Approval of Reserved Matters Consultation

Application Number: 251263

Site Address: Parcel 6, Finchwood Park, Sheerlands Road, Arborfield, Wokingham, RG40 4QY

Proposal: Application for approval of Reserved Matters pursuant to Outline Planning Consent O/2014/2179 (as varied by 181194, dated 14/11/2018). The Reserved Matters comprise details of 140 dwellings, together with associated internal access roads, parking, landscaping, footpath and sustainable urban drainage systems (SuDS). Details of access, appearance, landscaping, layout and scale to be considered.

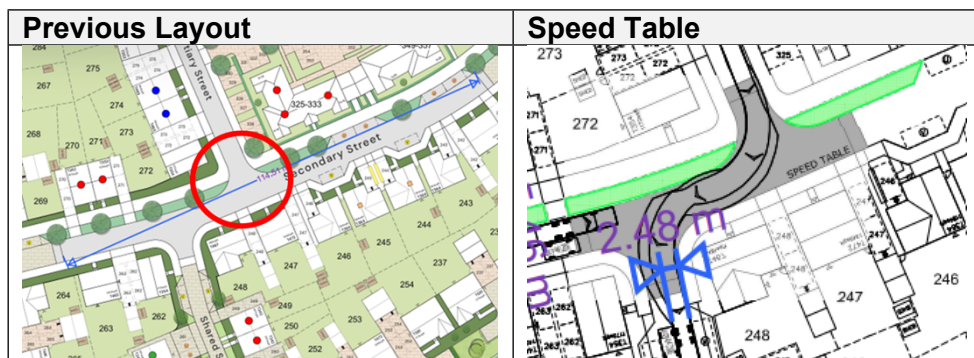
8. There is a straight distance of c.114m without changes in the alignment of the road or any traffic calming features and therefore additional traffic calming features should be introduced.

9. The junction circled below would also benefit from a tabled crossing to prioritise pedestrians and cyclists using the 3.0m wide shared use path.

a. **19.03.26: The LHA note that a raised speed table is now shown at the junction in question. This request is resolved.**

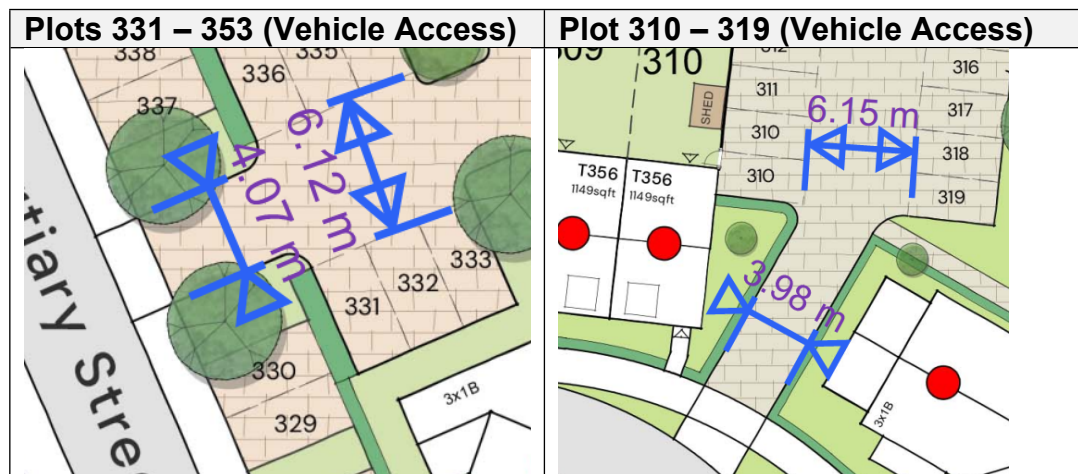
10. Many of the private drives, shared surfaces and car park accesses on the proposed site plan only measure 4.1m wide, which is not wide enough for two modern vehicles to pass each other. The LHA require these accesses to be 4.5m wide. The Wokingham Living Streets Guidance (2019) specifies a minimum width of 4.5m for accesses to Mews, Housing Squares and Parking Courts. This is to allow two vehicles to pass each other and prevent vehicles needing to reverse out onto the main streets when confronted with a vehicle travelling in the opposite direction.

11. The internal access only measures 4.07m wide for parking spaces 331 – 357 for plots 334 – 357. A minimum width of 4.8m should be provided to allow two vehicles to pass each other; otherwise, vehicles will need to reverse out onto the street. Given this car park has 20 spaces, it is likely cars will encounter one another frequently.

12. The access is also 4.0m wide for the parking at plots 310 - 319. This should also be increased to a minimum of 4.8m wide.

a. **21.01.26: The LHA consider this request resolved, the access to the spaces for 331 - 337 now appears 4.8m wide.**

- a. The LHA also consider this request resolved. The access to the spaces for 310 – 319 now appears to be 4.8m wide.

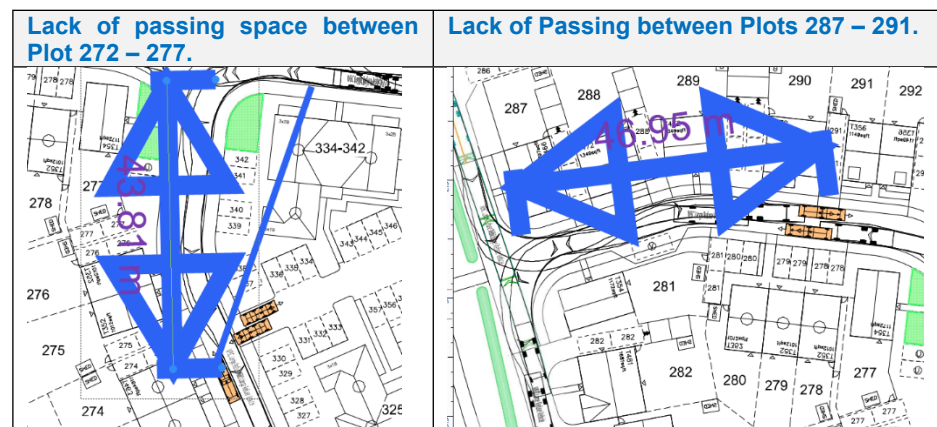
d. In numerous instances on the site plan, the private car would not have suitable forward visibility of an approaching RCV whilst it turns the corner. Blue lines illustrate where a car would have forward visibility of the RCV obstructed by a dwelling: **Forward visibility added for first case, others are junctions and therefore forward visibility does not apply.**

i. 19.03.26: The LHA accept this explanation.
